**Evaluation of DOE Report:  
*Annual Report in Support of Compliance Plan No. CP-50284-000*, April 1, 2005**

**Effectiveness of the Perched Aquifer Pump and Treat System  
December 2005**

This is an evaluation of the Department of Energy's (DOE) report: *Annual Report in Support of Compliance Plan No. CP-50284-000*<sup>1</sup>. This evaluation was performed for STAND, an organization of concerned citizens.

Figure 1

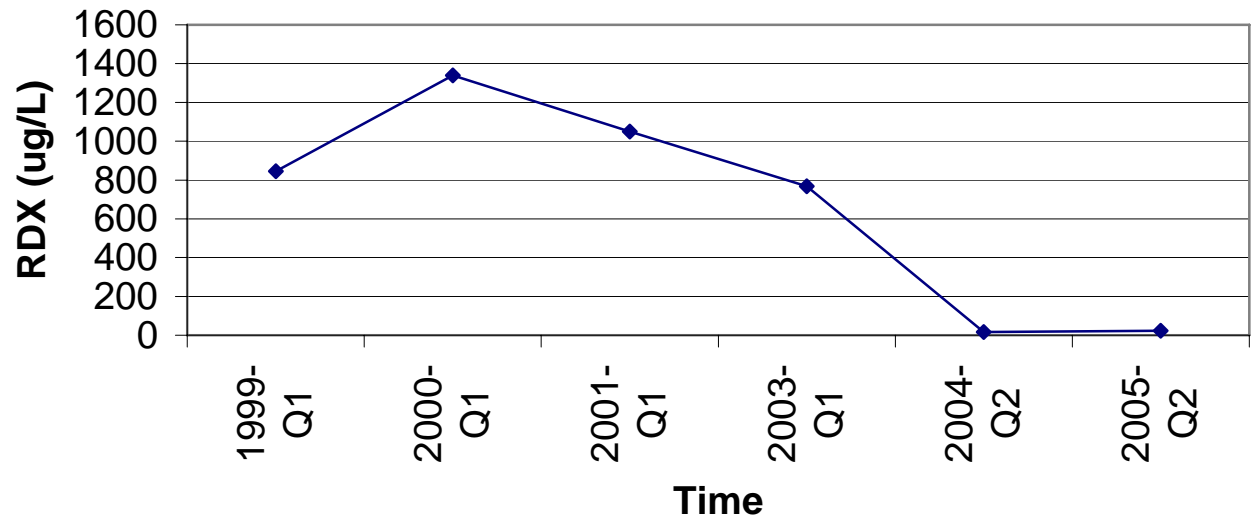
To date, cleanup appears to have been effective in only one of the selected wells: PTX06-1005 (figure 1). Between 1999 and 2005, RDX concentrations dropped from approximately 1000 µg/L to 20 µg/L. This is less than the TCEQ Industrial Risk Reduction Standard 2 level of 26 µg/L<sup>3</sup>. However it is higher than the EPA lifetime health advisory of 2 µg/L<sup>4</sup>. Well PTX06-1005 is near a clean-up system injection well<sup>5</sup>. This may be the reason RDX concentrations have decreased as much as they have.

### RDX, PTX06-1042

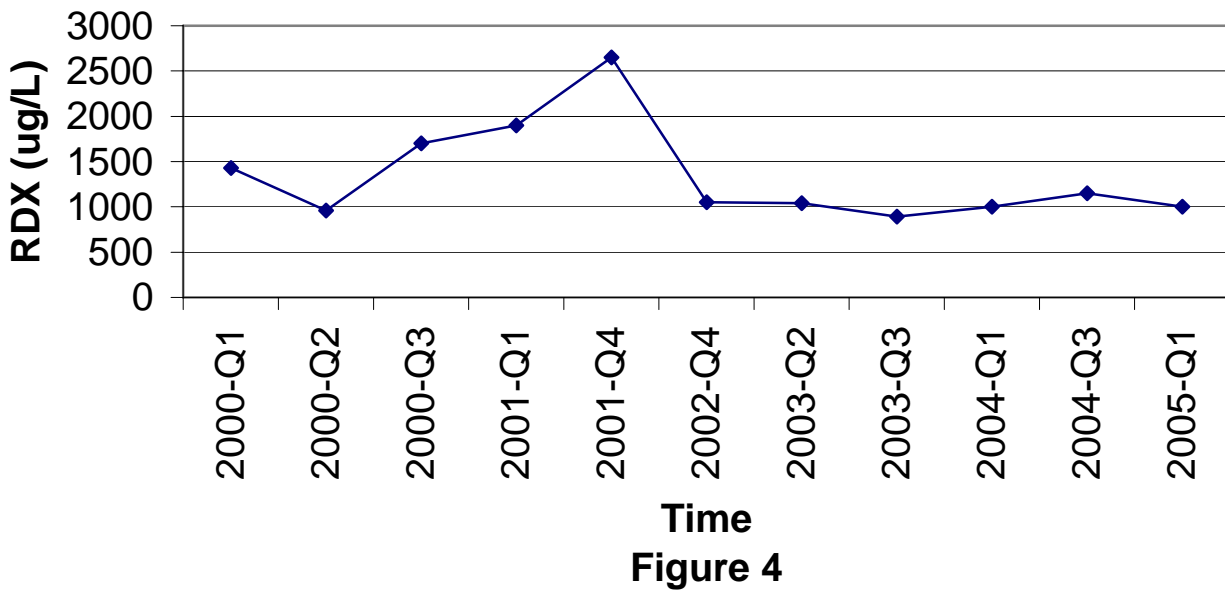
RDX concentrations have declined in some wells (e.g., PTX06-1042, figure 4) and increased in others (e.g., PTX06-1046, figure 5). Still, except for well PTX06-1005, RDX concentrations remain high in all the wells (figures 2 – 7), far above any standards established to protect human health.
